## **Proposal for Amendment 1 to global technical regulation (UN GTR) No.16 (Tyres)**

The text reproduced below is based on ECE/TRANS/WP.29/2016/70 adopted by the Working Party on Brakes and Running Gear (GRRF) at its eighty-first session (ECE/TRANS/WP.29/GRRF/81, para. 30). It is also based on ECE/TRANS/WP.29/GRRF/2016/2.

In the corresponding provisions of the text below, the comparison contents of the applicable China tyre regulations are given by the following example color labelling:

Figure x1 Schematic diagram of dimensional measurement of tire

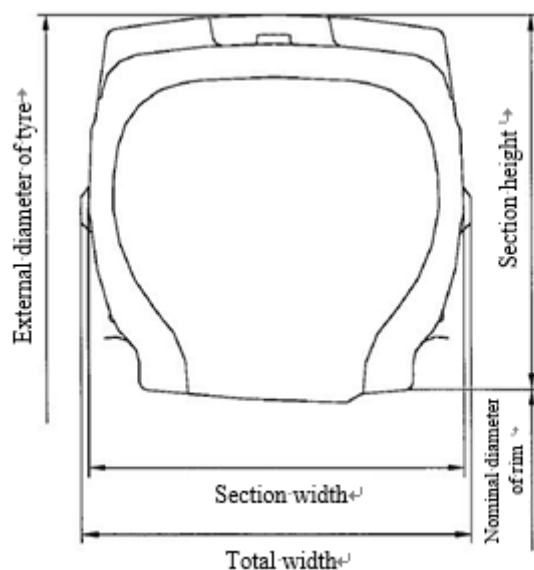
3.20.2.2 Width of tyre section

3.20.2.2.1 On the side of tire without marks, decorative rib, and kerbing rib, measure the section width at four points with same interval using vernier caliper or calliper (Fig.x1) in mm and round number. If it's inevitable to include marks, decorative rib, and kerbing rib, the additional thickness shall be subtracted from measured value.
